digital		ORIGINATOR Tom Off 1-2 TEL EXT 2791 DATE 11/17/72 DISC PROJ NO E20-06734 COST CENTER NO 378		ECO NO. <u>M7254-0001</u> SHEET <u>1</u> OF <u>1</u> DATE RECEIVED <u>11-30-72</u> FIRST ISSUE <u>12-4-72</u> FINAL ISSUE <u>12-17-72</u>			
ENGINEERING CHANGE ORDER <u>9167</u>				UNIT TO BE CHANGED M7254 Etch REV C DISC CODE 03			
PROBLEM 1) RK11-D samples word count overflow at sector end time to determine if a transfer is complete. This gives premature termination of write and write check functions during short sectors. 2) Temporary availability problems with T.I.7427 #19-1087C				OPTIONS AFFECTED RK11-D,E			
CORRECTION 1) Use file done signal from M7256 instead of word count overflow for sample at sector end. 2) Add 8875 #19-10647 to parts list as an alternative to 7427.				PRODUCT LINES AFFECTED PDP-11			
BREAK-IN/EFFECTIVITY Rework all M7254 Rev C Loads.							
ITEM NO	DOCUMENT/PART NO	OLD REV	NEW REV	DISP CODE	DESCRIPTION OF CHANGE		
1.	D-CS-M7254-C-1	B	C	06	Sheets 1, 2, 4, & 6 -Sec final release drawing.		
2.	B-MH-M7254-0-6	A	A	06	See final release drawing.		
3.	XXXXXXXXXX	D	D	03	Make the following etch changes: 1) Delete: AP1-E0204, E02 13 2) Delete: E0602-A01 3) Add: AP1

THIS DRAWING IS PART OF E.G.O. PACKAGE # **M7255-00008** **NOT TO BE USED FOR PRODUCTION**

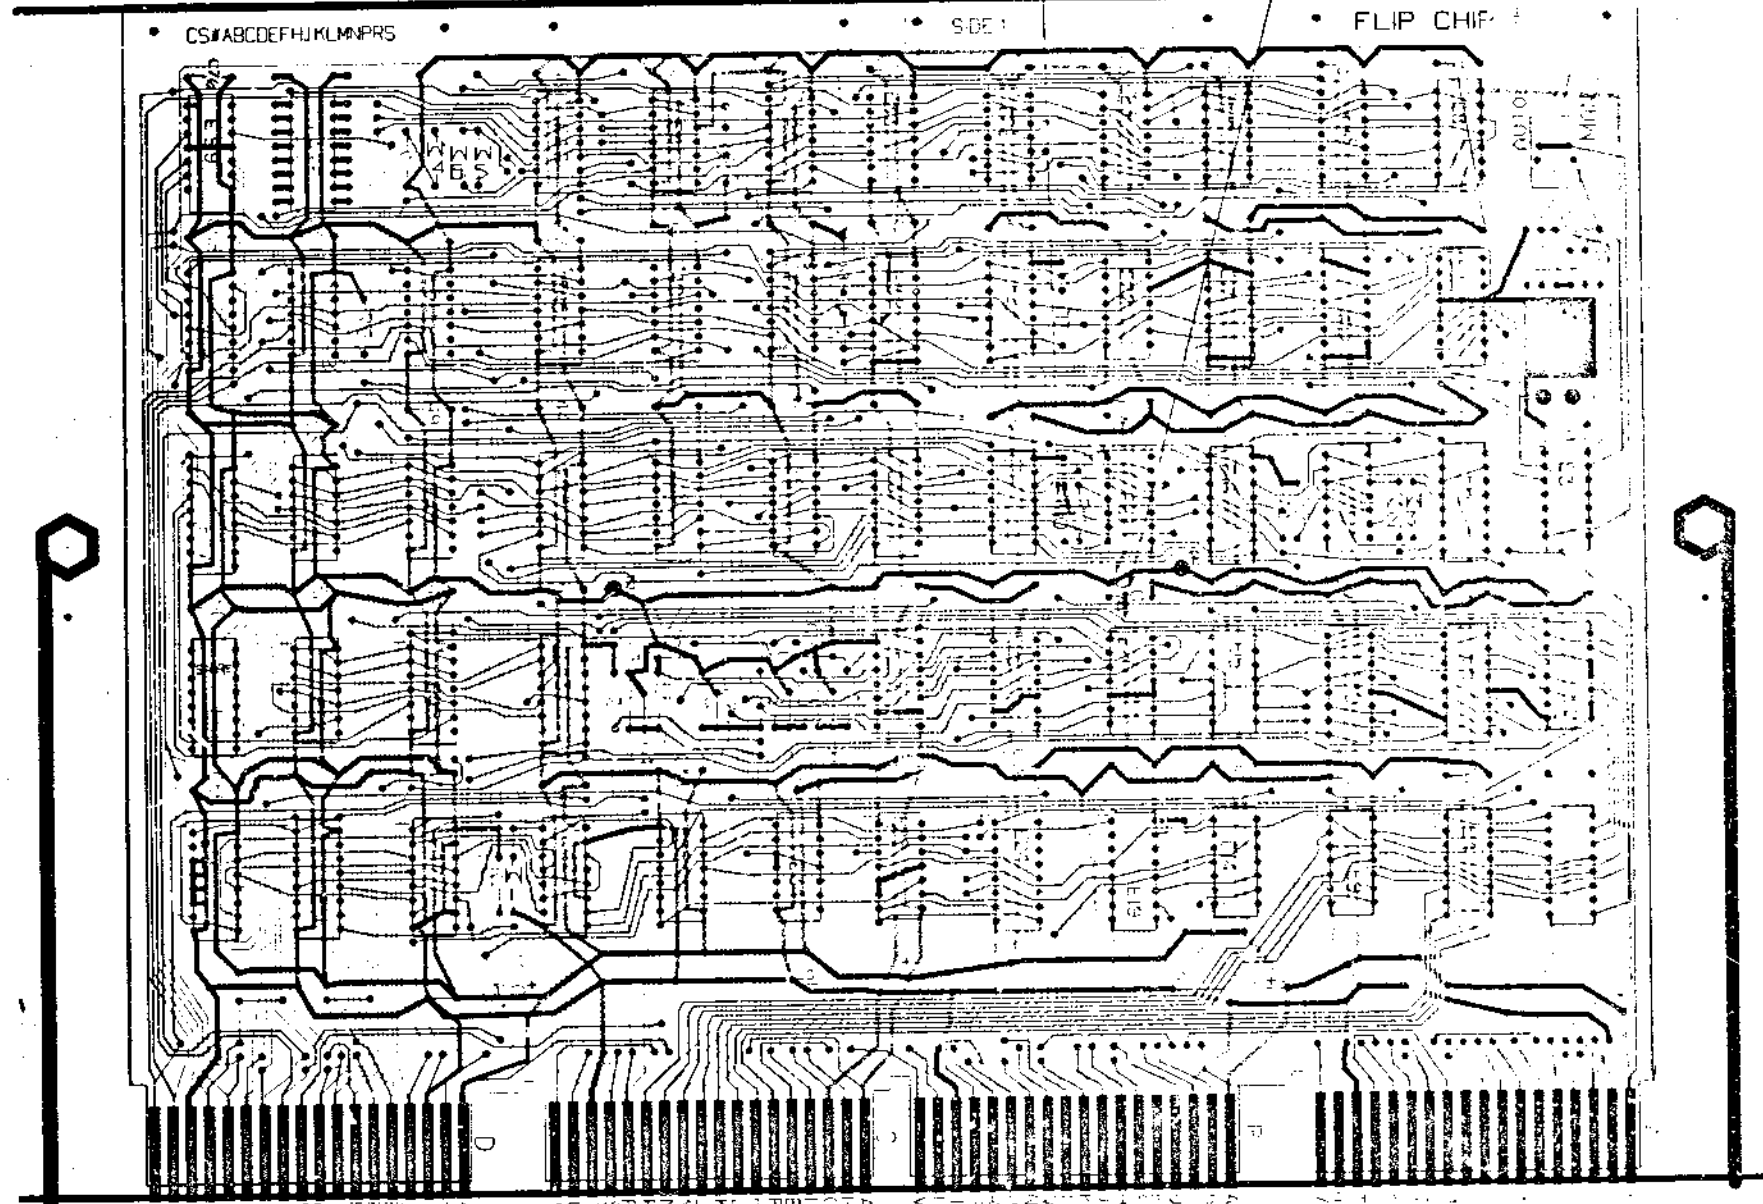
<table><tr> <th>ITEM NO.</th> <th>DOCUMENT/PART NO.</th> <th>OLD REV.</th> <th>NEW REV.</th> <th>DISP CODE</th> <th>DESCRIPTION OF CHANGE</th> </tr><tr> <td></td> <td>Sheet 2</td> <td>E</td> <td>F</td> <td>06</td> <td>Remove E32, R3 and C71 from Part List.</td> </tr><tr> <td></td> <td>Sheet 5</td> <td>D</td> <td>E</td> <td>06</td> <td>Remove E32, R3 and C71 from Circuit Schematic.</td> </tr></table>

DELETE C71 M7255E P2MS40187 DELETE C72 DELETE C73 DELETE C74

THIS DRAWING IS PART OF E.C.O. PACKAGE # *M7255-00009* **NOT TO BE USED FOR PRODUCTION**

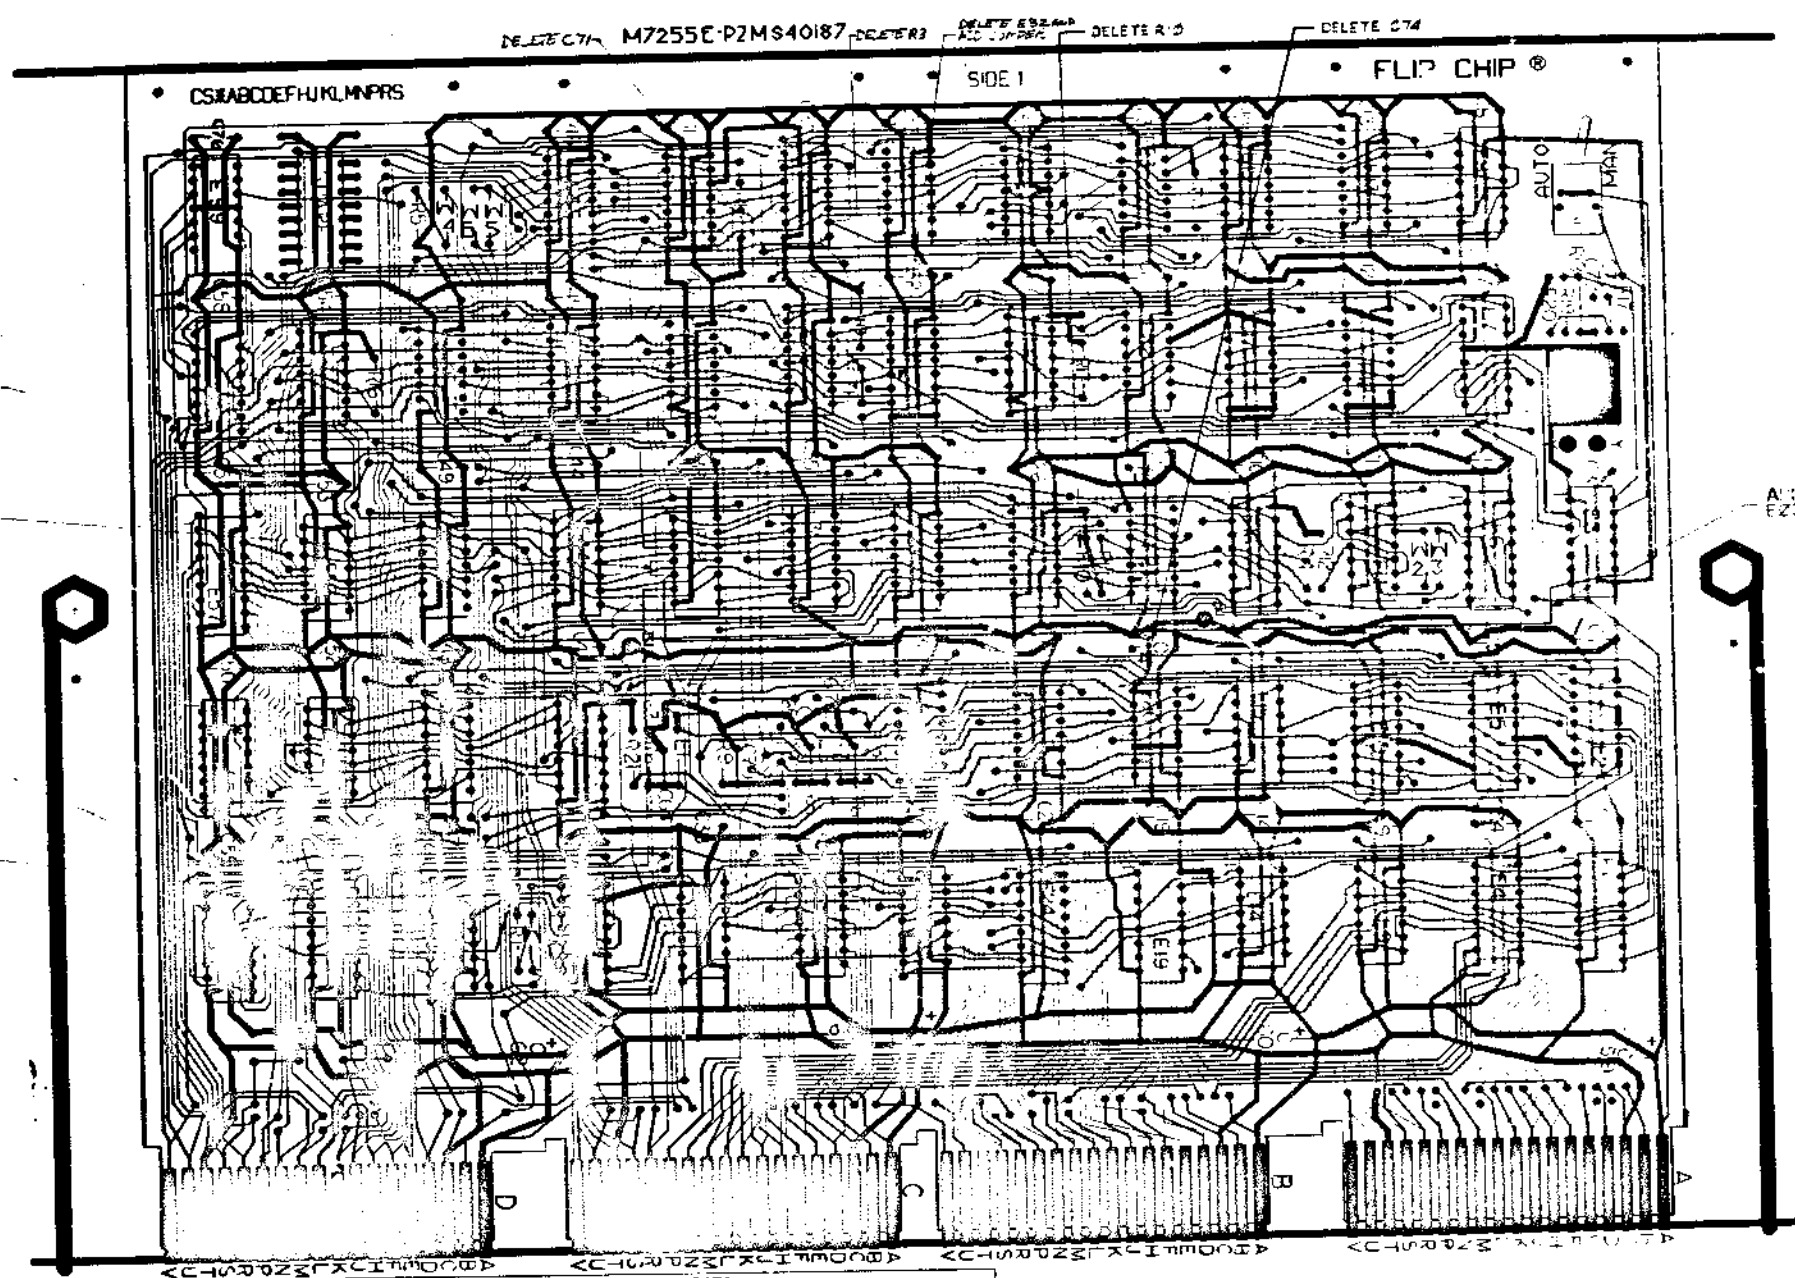
ADD WIRE FROM E2307 TO E3925

NOT TO BE USED FOR PRODUCTION

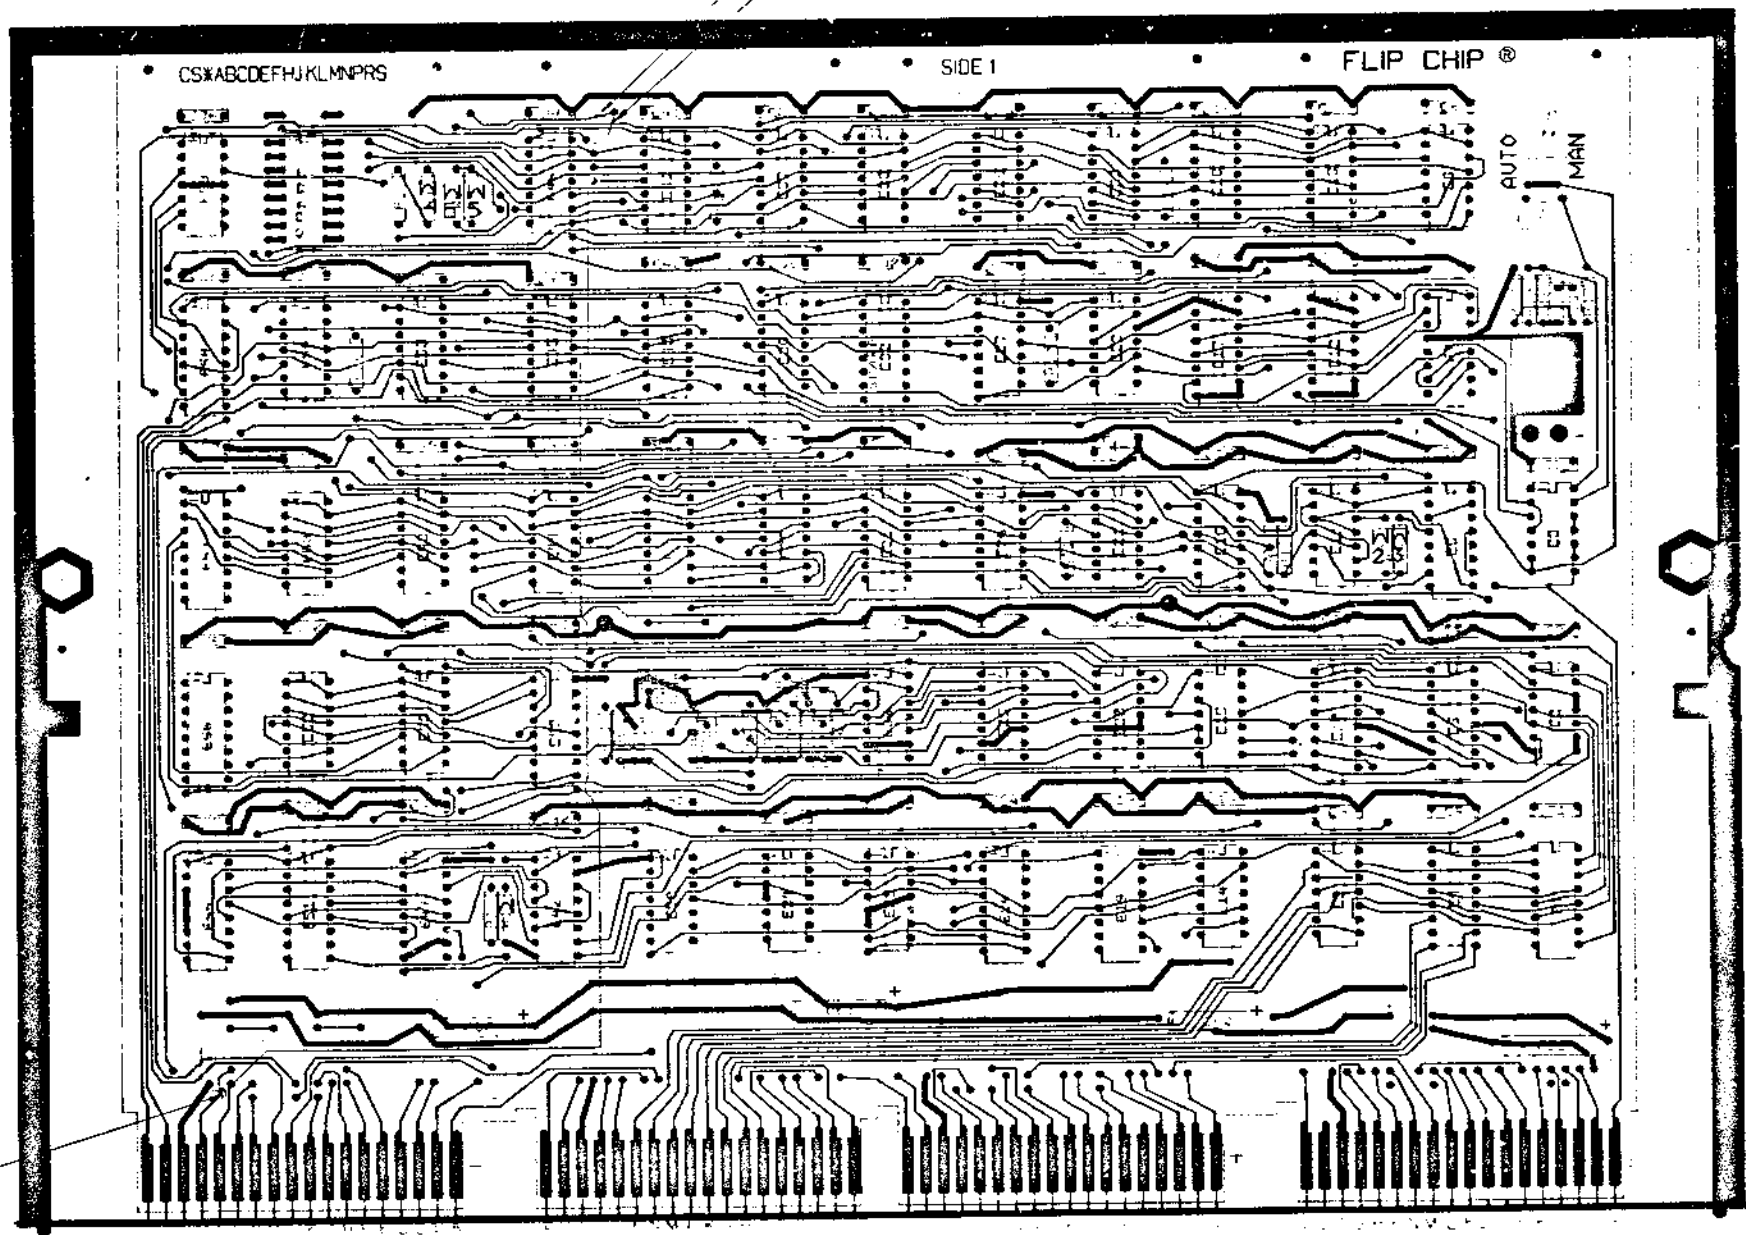
ITEM NO.	DOCUMENT/PART NO.	OLD REV	NEW REV	DESCRIPTION OF CHANGE/POSITION OF MATERIAL
1.	B-AH-M7255-0-6	U	V	UPDATE REV. AND RECORD THIS ECO.
2.	D-AH-M7255-0-5	P	R	UPDATE REV. 1. CUT ETCH SIDE 2 THAT CONNECTS PTH TO PIN DRI. 2. CUT ETCH SIDE 1 AT THE PTH BETWEEN C41 AND C-6. 3. ADD JUMPER SIDE 1 FROM PTH CONNECTED TO DRI TO PTH LOCATED BETWEEN C41 AND C46.
3.	B-CS-M7255-0-1 (SHEET 1)	P	R	RECORD DRAWING REVS.

REWORK INSTRUCTIONS:
 ECC #1
 #1 ADD JUMPER FROM PTH CONNECTED TO DRI TO PTH LOCATED BETWEEN C41 AND C46.
 #2 CLIP ETCH, SIDE 1, AT PTH LOCATED BETWEEN C41 AND C46.
 #3 CUT ETCH, SIDE 2, AT PTH CONNECTED TO P41J DRI

THIS DRAWING IS PART OF E.C.O. PACKAGE # M7257-00011 NOT TO BE USED FOR PRODUCTION

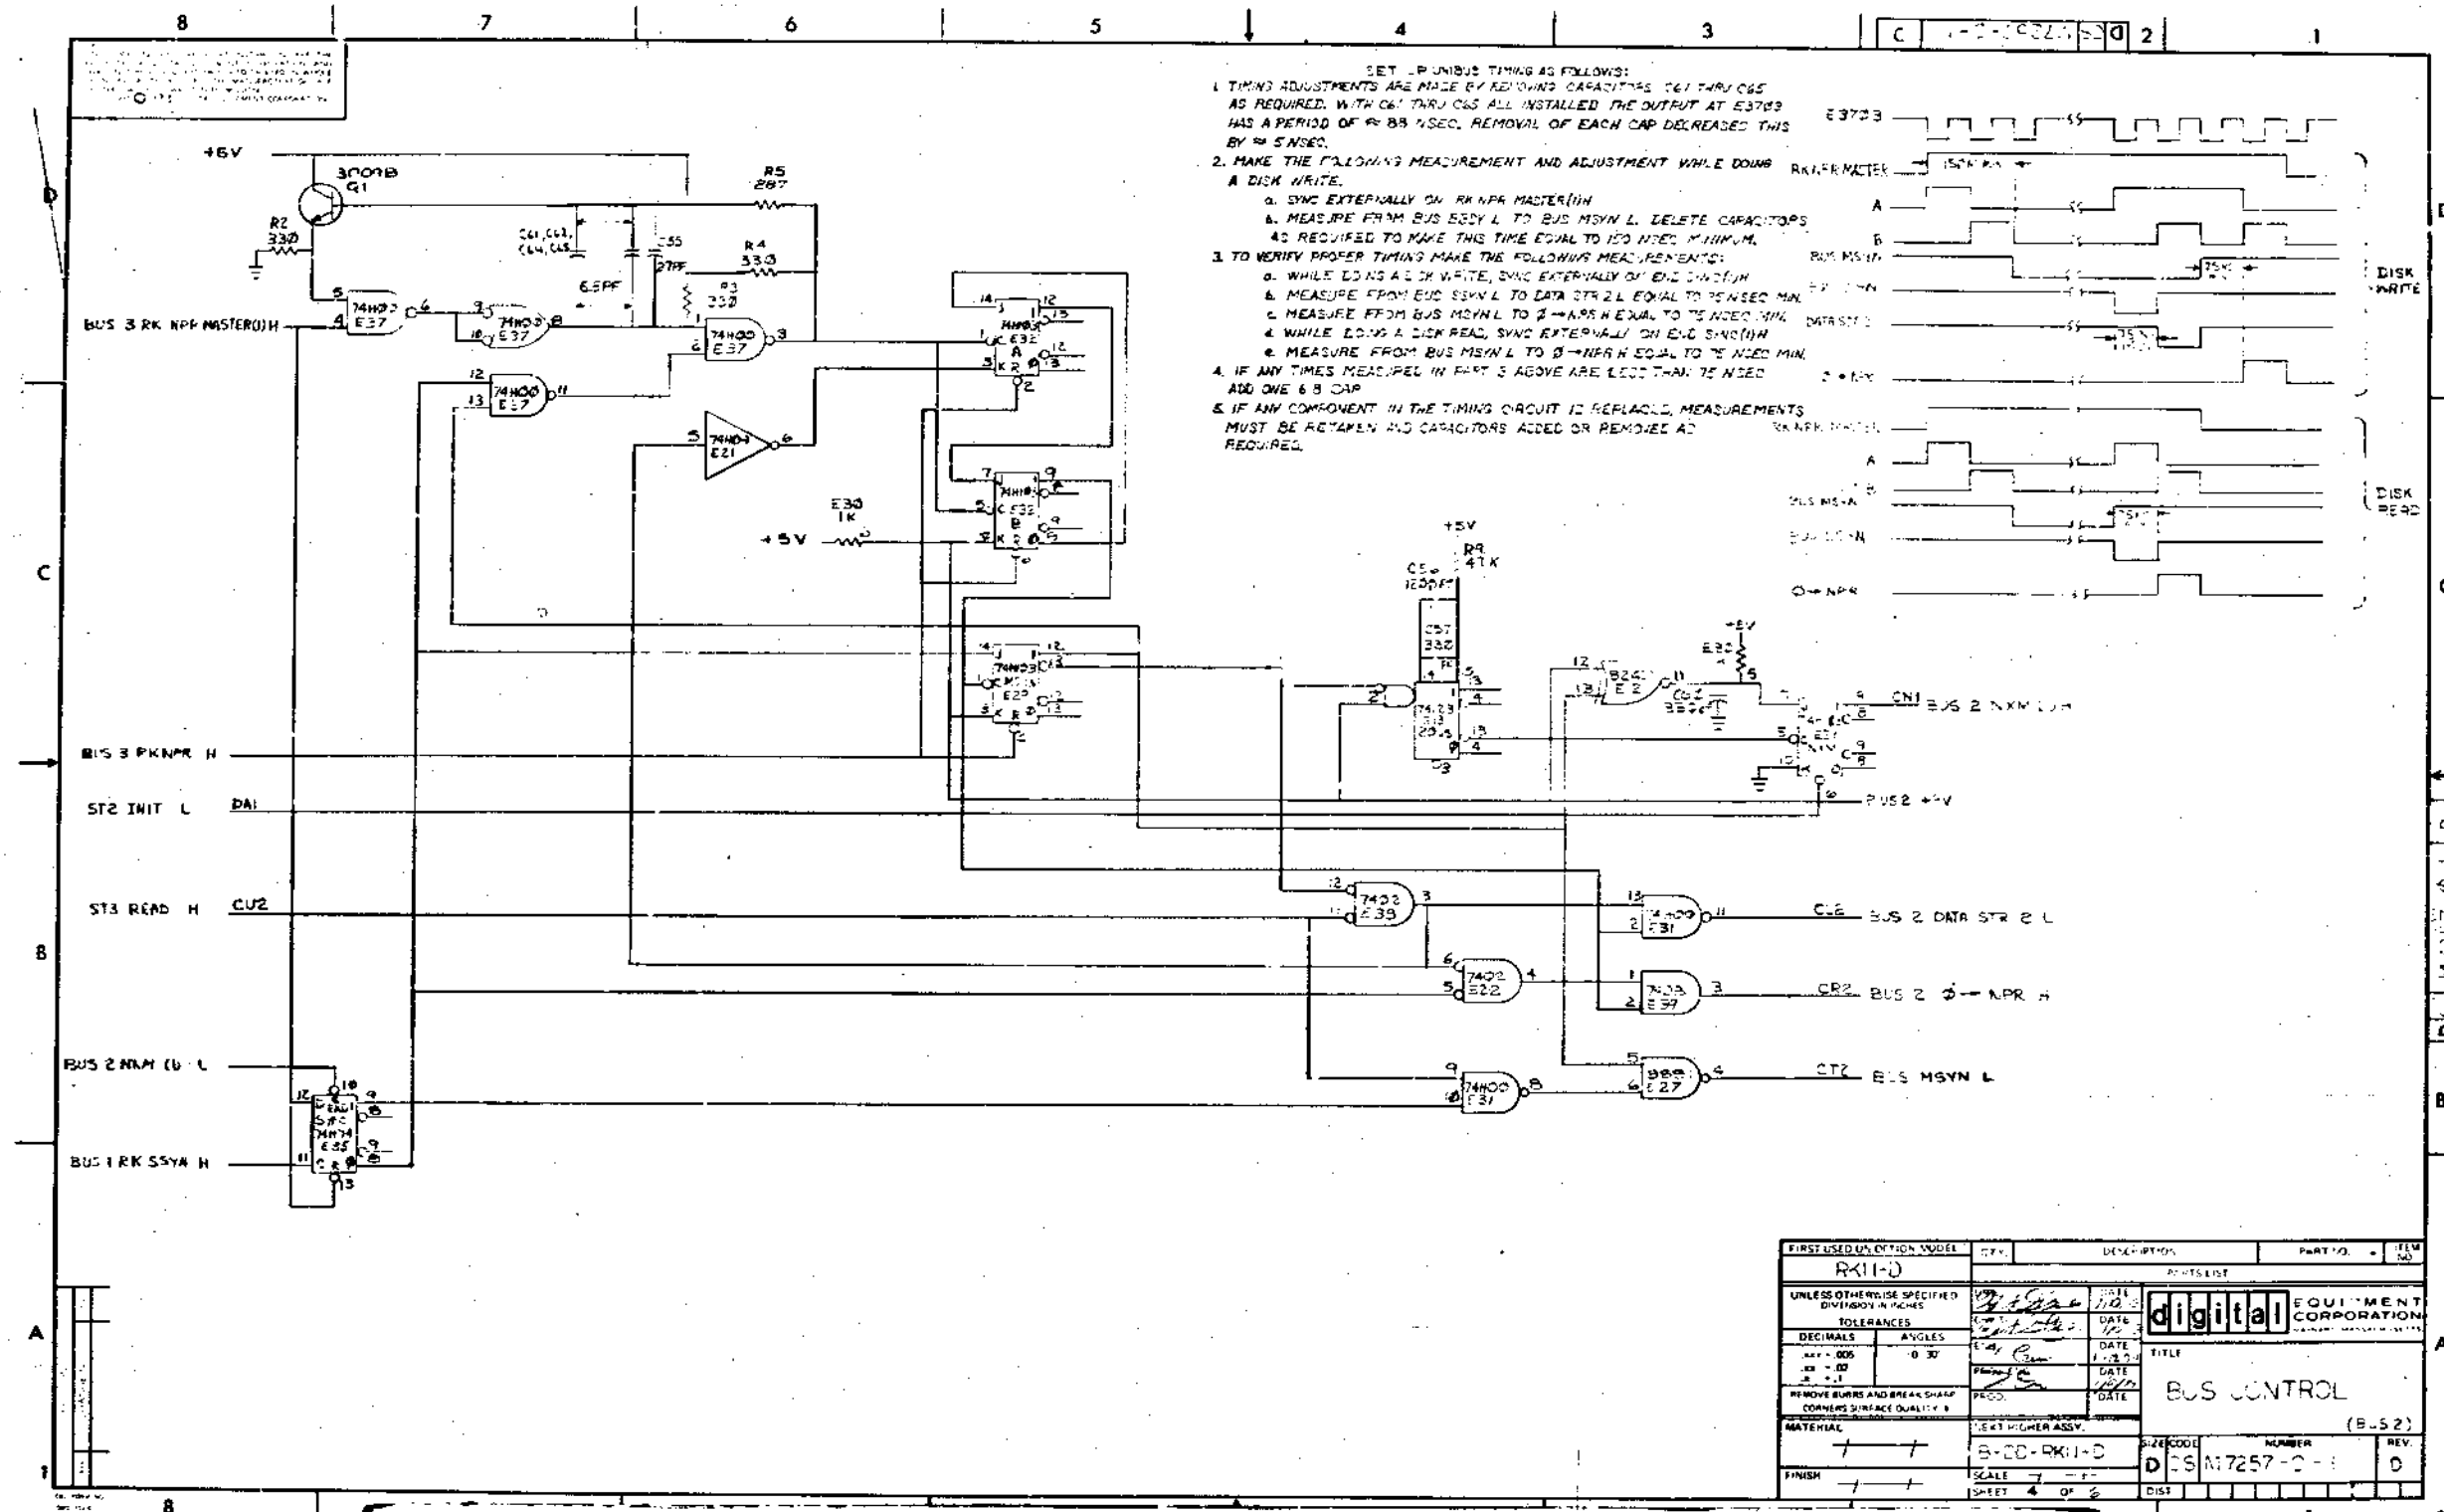
SET UP BUS TIMING AS FOLLOWS:
 1. TIMING ADJUSTMENTS ARE MADE BY REMOVING CAPACITORS C1 THRU C6 AS REQUIRED. WITH C1 THRU C6 ALL INSTALLED THE OUTPUT AT E3703 HAS A PERIOD OF 98 NS. REMOVAL OF EACH CAP DECREASES THIS BY 5 NS.
